Your Ref:DC/19/03486
Our Ref: SCC/CON/3036/19
Date: 7 January 2020

CONSULTATION RETURN: DC/19/03486

PROPOSAL: Outline Planning Application (some matters reserved - access to be considered) -

LOCATION: Land south west of Beyton Road Thurston Suffolk

A143/C691 Bunbury Arms junction

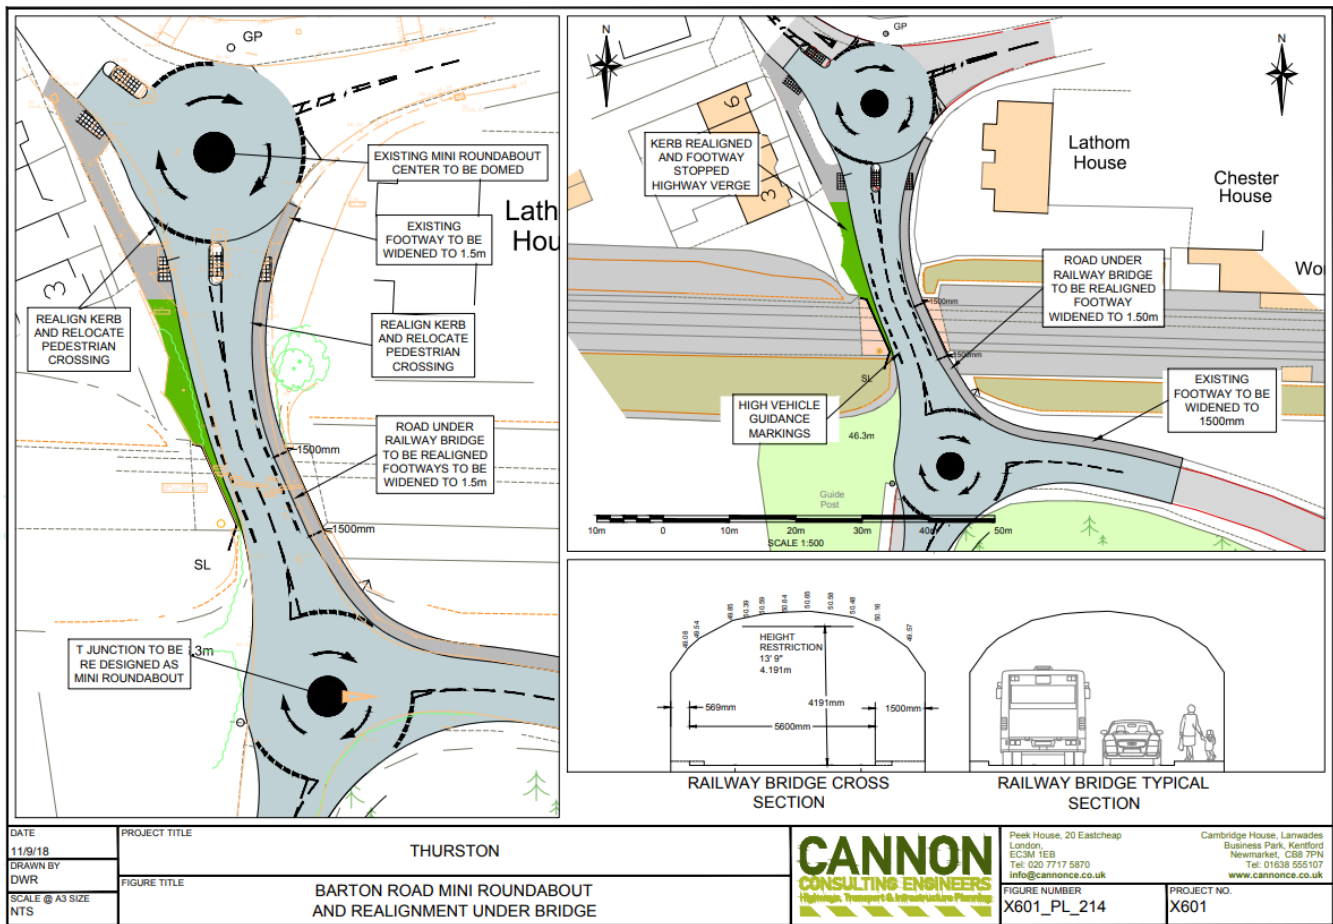
Existing situation	Proposed mitigation
<p>The mitigation from the 2017 developments included signalling the junction. The junction will be at capacity on two arms in the AM peak hour for the granted applications. This was accepted as the developments had mitigated their impact, but it was not possible to fully mitigate the background growth due to space constraints.</p>	<p>The proposed mitigation with contributions from the previous 5 applications, the 2019 AECOM indicates that the one arm of the junction will be over capacity during the AM peak hour and at capacity on two arms. On further assessment of the model data, we believe there is scope to improve the proposed preliminary design of the signals using better software and monitoring systems to improve capacity. However, no further mitigation, in terms of highway layout, is considered possible within the highway boundary.</p>

The impact on this junction is minimal from this development’s traffic as the dominate movement is south or west; towards the A14. Modelling in the applicant’s Transport Assessment shows the junction percentage impact from this site would be less than 1%. It has been assumed that the direction of trips can be based on census data showing their destination. Also, due to its location south of the railway line, it is likely that drivers are more likely to travel via the A14 to reach destinations West and North of Bury St Edmunds and trips via the Bunbury Arms Junction will be less than anticipated.

We also believe that the provision of a signal junction at the A143 junction will potentially result in a redistribution of traffic due to the additional delay for left turn out movements. The signals could also increase the right turn movements from Thurston, as it becomes more attractive manoeuvre no longer being directly opposed.

Barton Road Mini Roundabout and Rail Bridge/Beyton Road junction

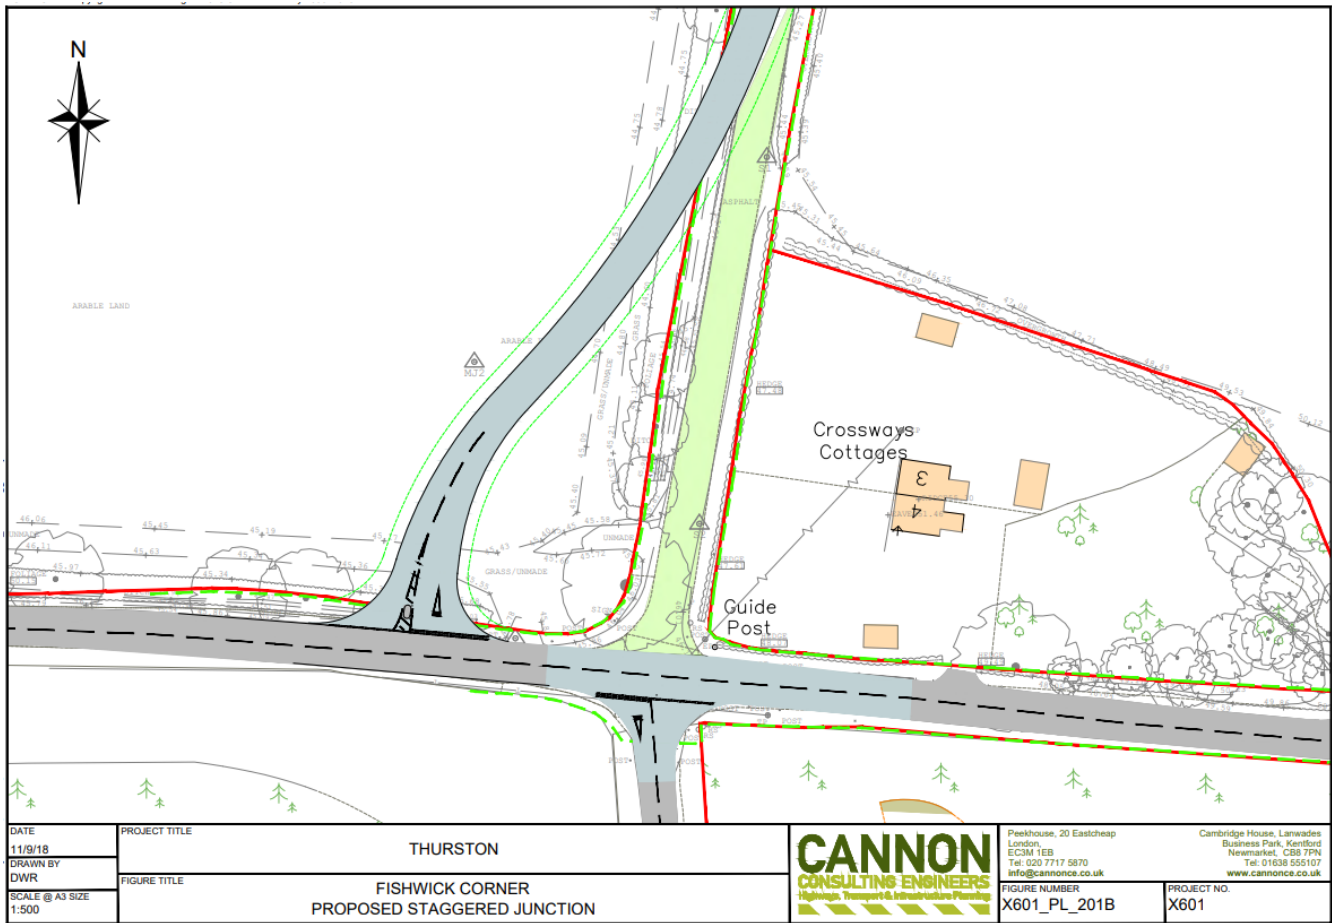
Existing situation	Proposed mitigation
<p>Barton Road under the railway bridge has sufficient carriageway width to allow 2 cars to pass. However, with the arch of the bridge, high-sided vehicles have to use the centre of the carriageway to use the maximum height of the bridge, therefore no other vehicles can pass large vehicles except cyclists. Due to the height restriction of the bridge, use by high sided vehicles is restricted (single deck buses can use this route). The footways under the bridge are narrow; where the west footway terminates adjacent to the south-west bridge abutment 490mm wide and the other has a pinch point of 750mm.</p> <p>The carriageway is not parallel with the bridge abutments which restricts the forward visibility from Beyton Road junction under the bridge to 24.5m.</p>	<p>By introducing improvements to the existing mini-roundabout and a new mini-roundabout on the Barton Road/ Beyton Road junction, this improves the RFC for Base + Committed Development + the Development from 1.00 to 0.85 and reducing delays by approx. 60 seconds therefore, improving capacity. By realigning the carriageway parallel with the bridge abutments, will improve the inter-visibility between the junctions on each side of the bridge. Removing the footway on the west side enables the footway on the east to be widened to 1.5m enabling safer passage for pedestrians making an acceptable walking route for existing and new residents. Access for cyclist remains poor as the footway is too narrow restricting them to the road and hence potential conflict with vehicles.</p>

Barton Road Rail Bridge: Straightening of the road will improve sight lines for drivers and provide a 1.5m wide footway on the east side. While the width of footway is less than desirable, particularly next to a busy road we have considered that on balance we would not consider it so unsafe as to recommend refusal.

However, this is a judgement made on the likely number of pedestrians from this development and any additional pedestrian use, particularly if it involves vulnerable users, would need to be reassessed. The problem of higher vehicles having to use the middle of the road to avoid the low arch remains a hazard

as does the limited capacity albeit with a degree of improvement to the flow by the proposed mini roundabout south of the bridge. Balancing the improvements in footway, better sight lines and alignment against the remaining limited capacity we consider that on balance This is regarded as a benefit in highway terms sufficient for this development.

C693 Thurston Road/C692 Thurston Road junction (Fishwicks Corner)

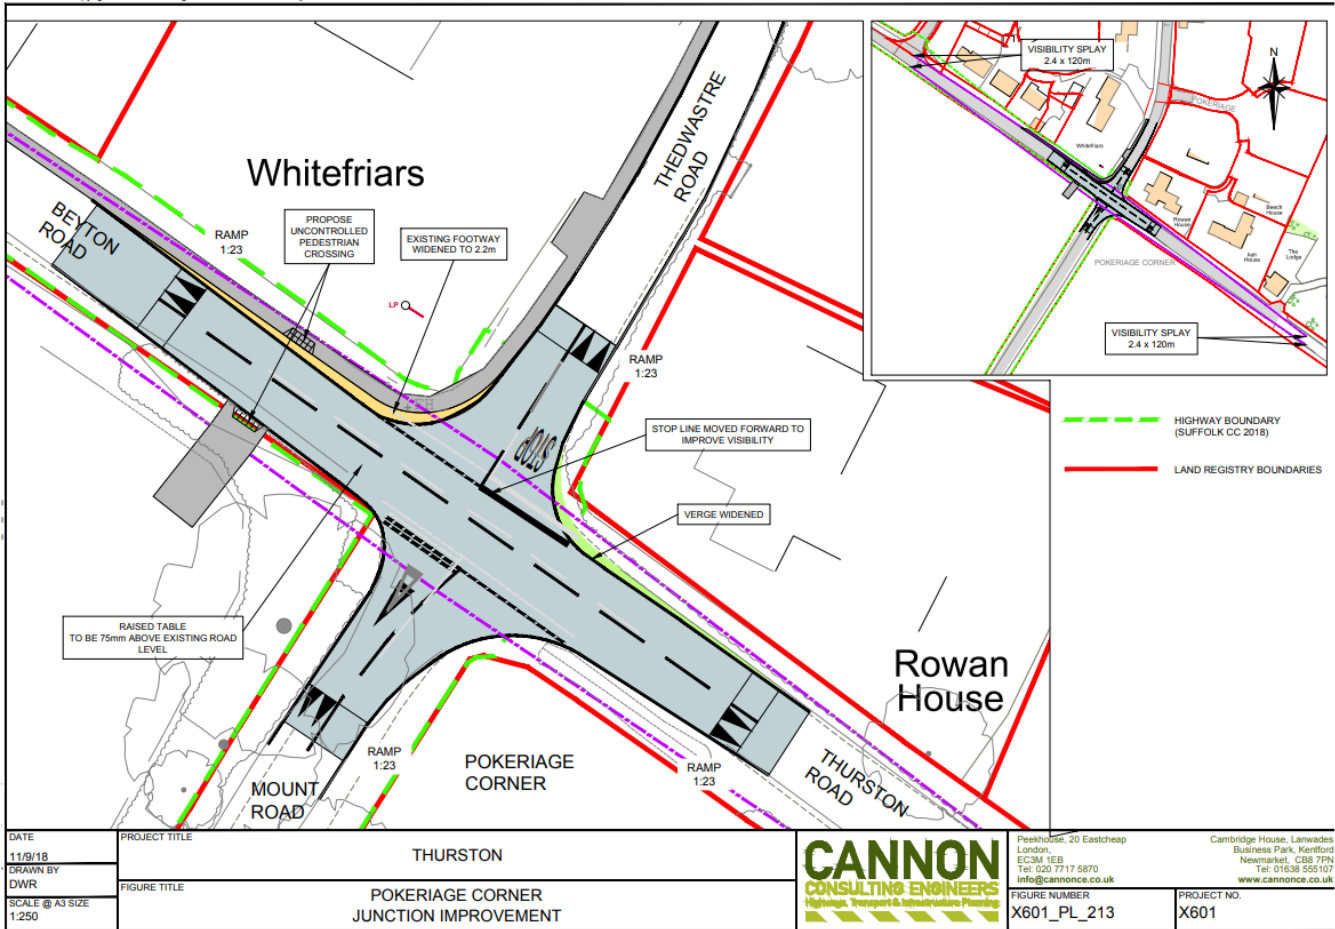
Existing situation	Proposed mitigation
<p>At Fishwicks Corner the primary cause for congestion is due to limited visibility at the junction. Being a crossroads with four-way movements also reduces capacity and adds to delays. The junction is an accident cluster site with 13 recorded injury accidents; 11 of which were drivers failing to look properly on the minor arms of the crossroads due to poor forward visibility. As part of the mitigation for the 2017 developments, a 40mph speed limit is being introduced with a change in the junction priority and altering the give-way scenario to Stop lines on the side roads. The predicted RFC with the 2017 developments following the revised layout of the junction was calculated as 0.93 in the PM peak.</p>	<p>The land to the north west of the junction is within the developers control so the highway boundary is no longer a constraint for further highway improvements to improve safety and capacity of the junction. The dominant turning movement in the AM peak is from Thurston Road (north arm) turning right to Bury St. Edmunds and in the PM peak, from Bury St Edmunds turning left into Thurston Road (north arm). By introducing a staggered junction, this improves the RFC for Base + Committed Development + the Development from 1.10 t(unmodified) o 0.58 and reducing delays by approx. 3 minutes therefore, improving capacity. Also, staggered junctions will provide the required visibility for the speed of road (40mph) and this type of layout has been shown to reduce accidents by some 60% compared to a crossroads. Recently, a preservation order has been applied to trees next to the existing junction but these are unaffected by the proposed new junction</p>

The question of a roundabout in this location has been raised by councillors. While an acceptable solution it is not concerned proportionate to the scale of the development as the proposal for a staggered junction delivers sufficient mitigation. Also, a roundabout would require a large area of land, are less safe for cyclists than to any other kind of road layout and there would be a need to remove more trees. possibly those recently protected. SCC have also requested additional area of land to be secured to allow for a future cycle/footway scheme if that is considered necessary.
